EVERGREEN

AN ADDITION TO WICHITA, SEDGWICK COUNTY, KANSAS

Re: S/D 9787 -- Final Plat of EVERGREEN ADDITION

STAFF REPORT

EVERGREEN

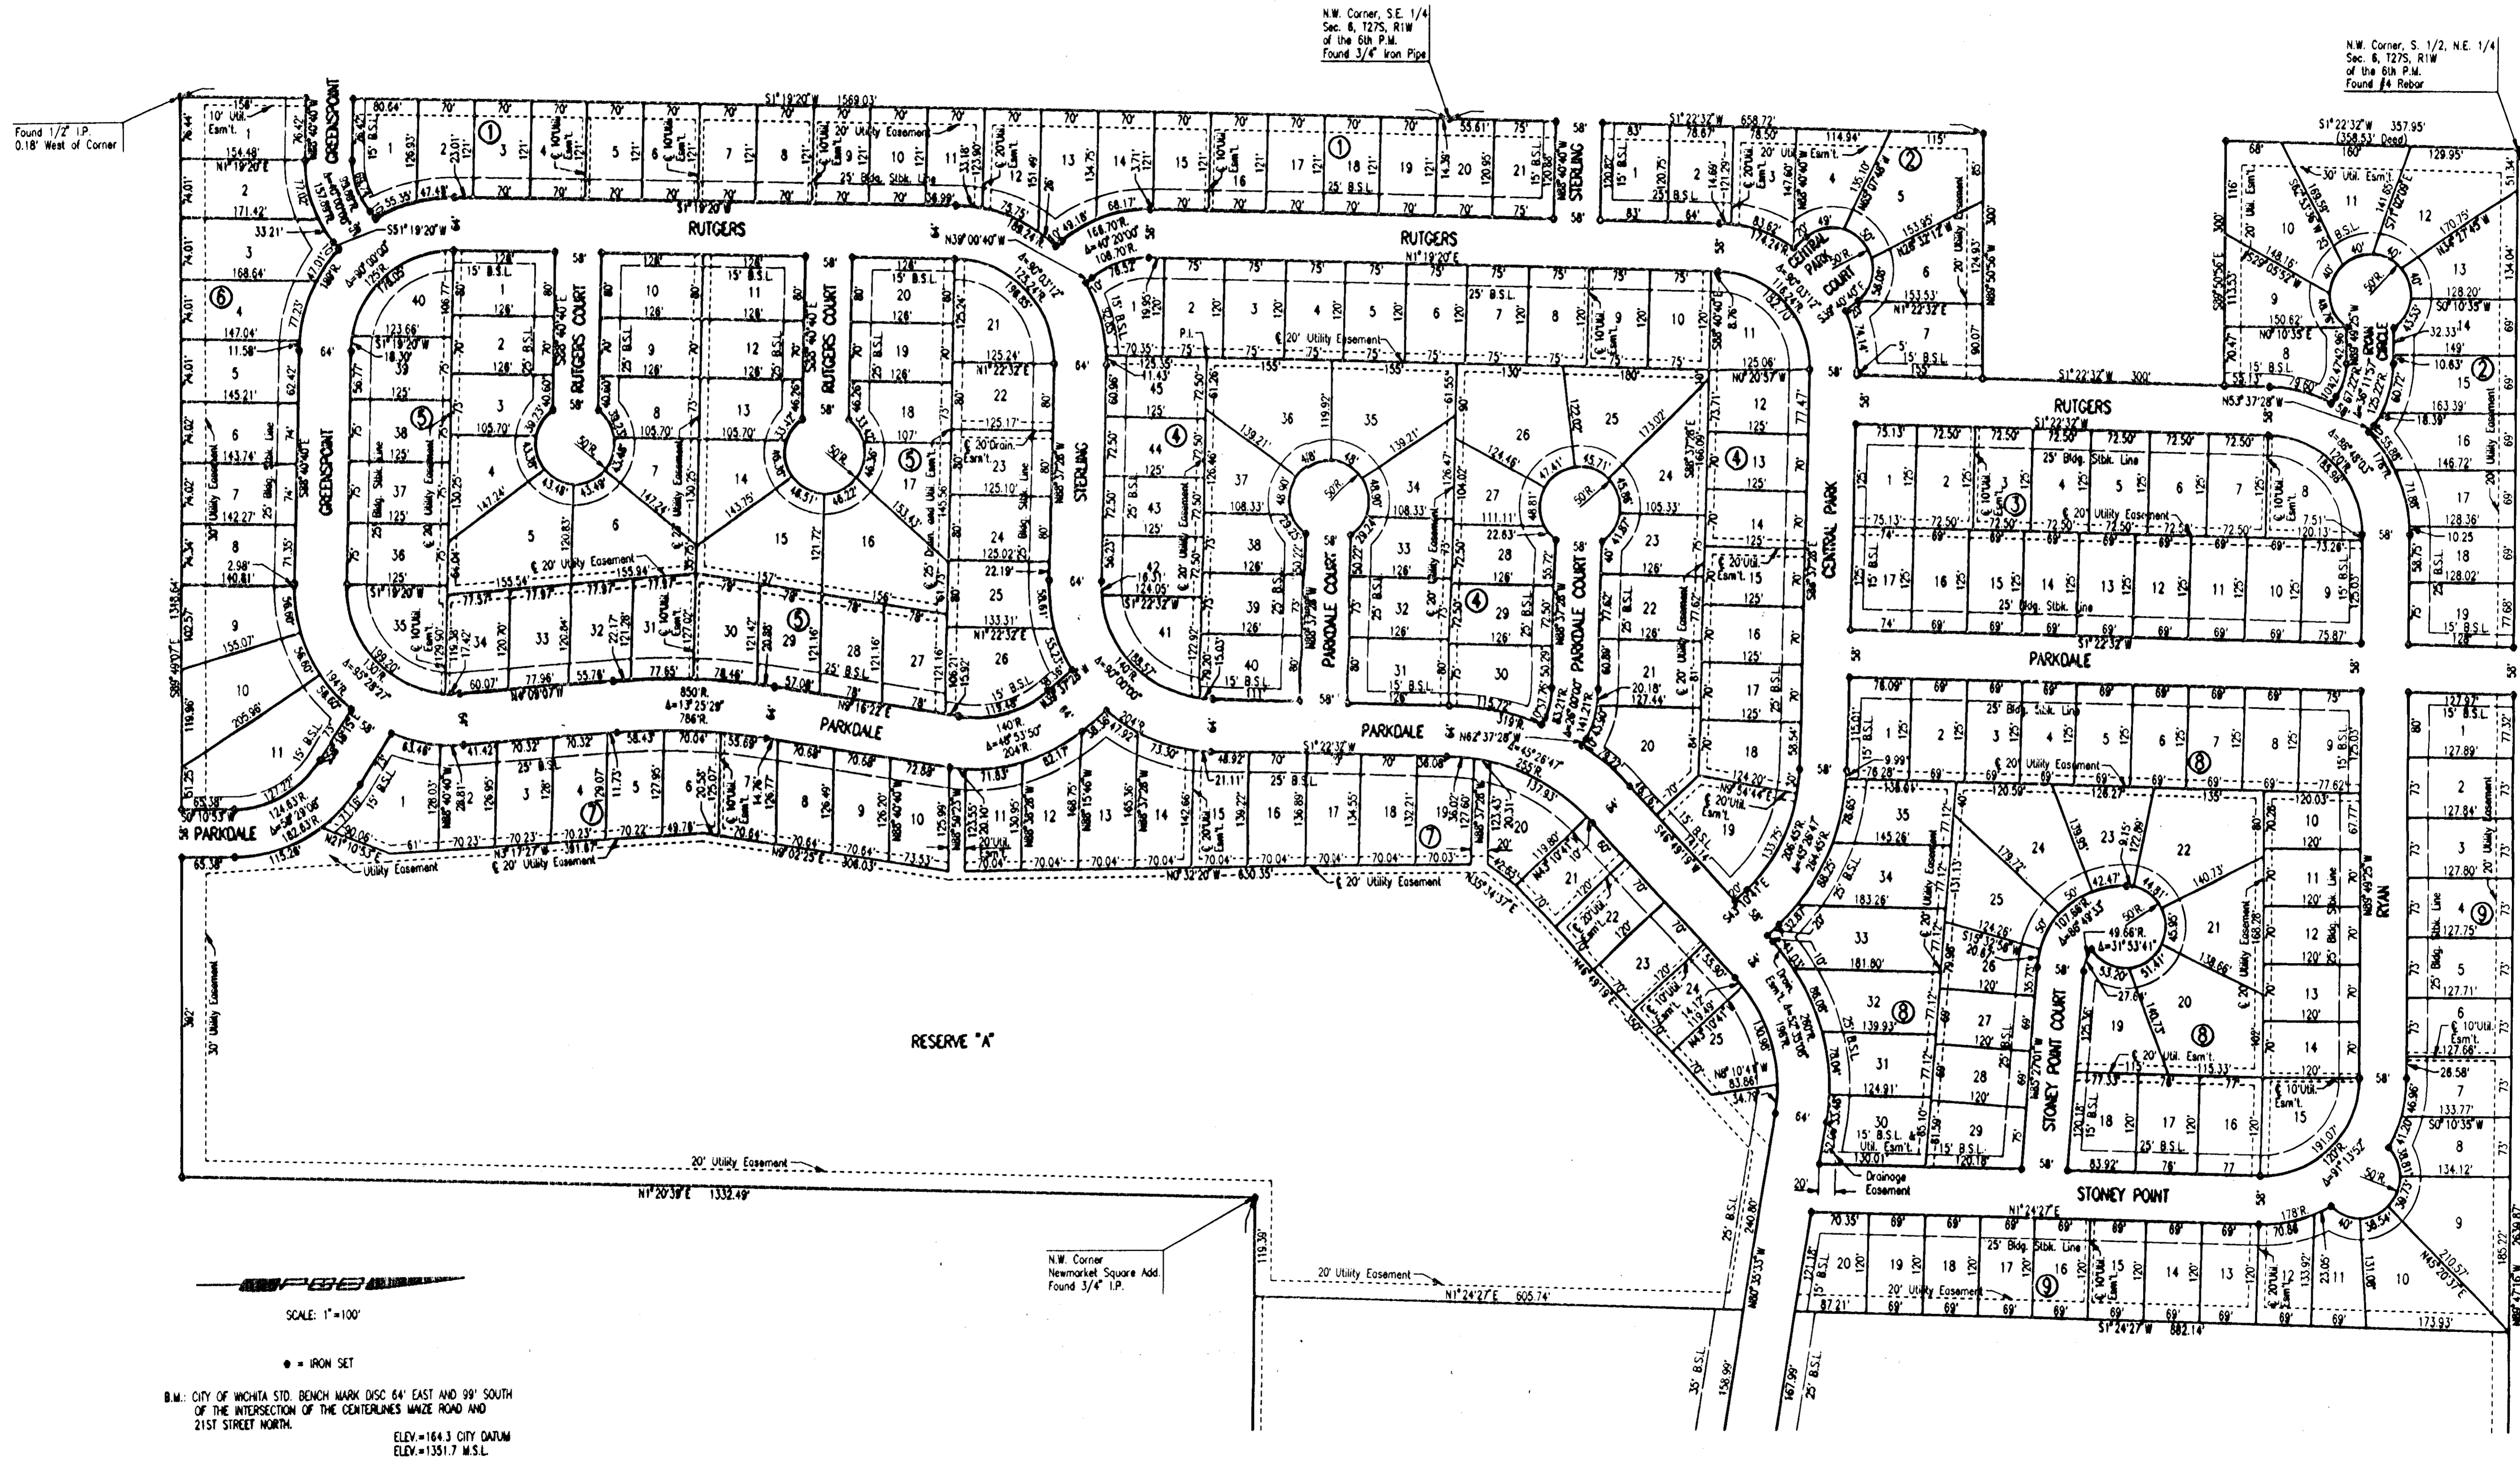
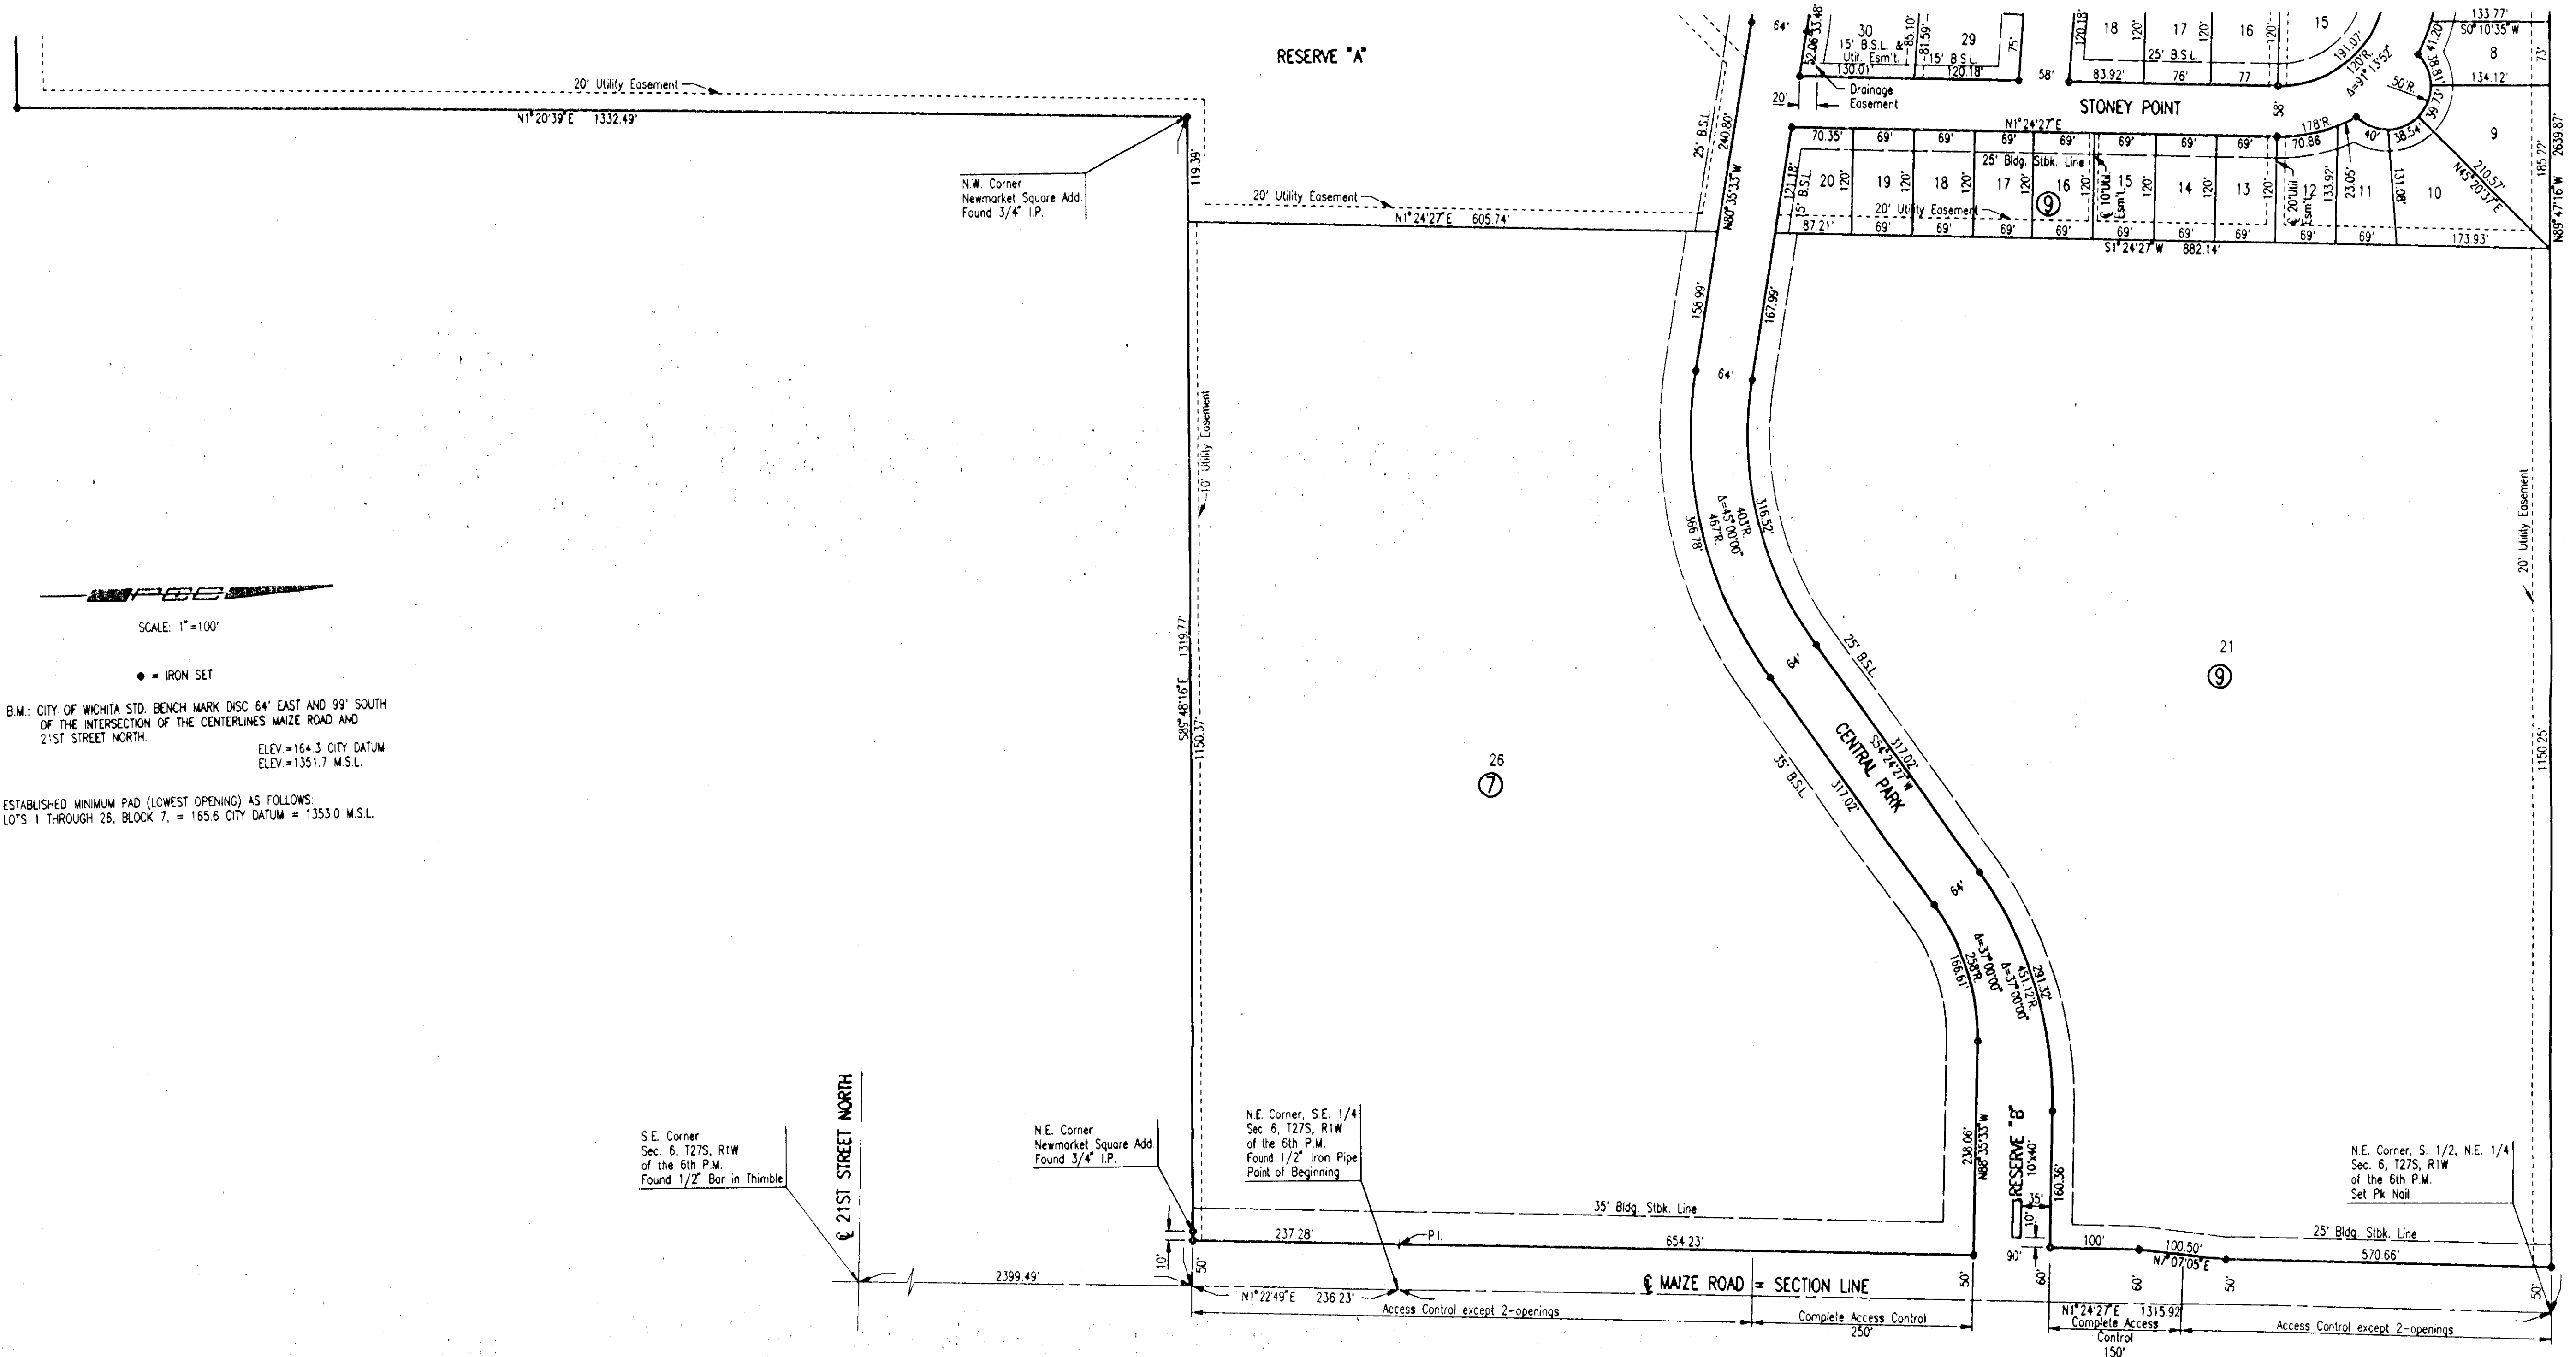
- A. The applicant shall guarantee the extension of sanitary sewer and City water to serve the lots being platted.

- B. The applicant shall guarantee the paving of the proposed interior streets. This paving guarantee shall also provide for sidewalks. The sidewalk ordinance requires sidewalks on both sides of Central Park from Maize Road to Reserve A. Sidewalks shall also be provided along one side of each looped or through-type street (i.e. Central Park, Parkdale, Greenspoint, Rutgers, Sterling, Stoney Point and Ryan).

- E. City Engineering needs to comment on the status of the applicant's drainage plan and if this plat has any minimum building pad requirements as a result of drainage areas (Reserves for lakes) being platted.

- F. Traffic Engineering needs to comment on the acceptability of the four access openings platted along Maize Road. On the final plat tracing, since the site is to be within the City limits of Wichita, the plattor's text shall note that the access controls are being dedicated to the City of Wichita and that the location of the openings are subject to the approval of the City Engineer.

- G. A street stub should be denoted to the south for increased mobility and potential connection with 21st Street North. *The applicant agreed to denote this stub on the final plat.*
✓ The final plat has indicated the requested street stub.

- H. The legal description in the plattor's text needs to be corrected to reference the bearing depicted on the face of the plat at the location of the southerly portion of the east line of the plat.

- X. The representatives from the utility companies should be prepared to comment on the need for any additional utility easements to be platted on this property. *The representative from KGE requested additional easements as denoted on the attached plat.*

Minimum pad building elevations will need to be platted for the lots adjacent to the pond. Lot 19 will need a drainage easement to be platted.

The drainage plan is approved.

The final plat has indicated the requested street stub.

The final plat includes the requested 35-foot setback.
